REQUEST FOR BIDDING INTERPRETATION (RFBI)

PMDB RFBI No.: 5

Project No.: 000000000008666
Project Name: DSH-Coalinga Hydronic Loop Replacement
Location: Coalinga, CA

Plan Detail (C - 4.2)

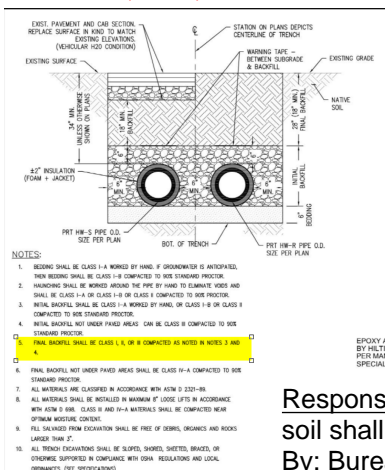
Drawing Reference: C - 4.2 Project Manual Reference: 33 20 00 - Earthmoving

Question: In review of the provided Soils Report, it appears that the native site materials consist of Fat Clay (CH).

Per Spec Section 33 20 00, Earthmoving, soils classified as CH are deemed unsatisfactory and not suitable for final backfill. However, the trench detail shown on Sheet C-4.2, represents that native site material can be used as trench backfill.

These two sections seem to be contradictory. Please clarify if native soils, specifically clayey soils, will be accepted as approved final backfill material. Or if the Contractor will need to import final backfill material (ie satisfactory soils).

Response: Use only approved suitable backfill materials per specifications. Unsuitable soil shall be removed from the site. Contractor shall import final backfill materials. By: Bureau Veritas, Orland Obtera (949.210.5781), 1-10-2025
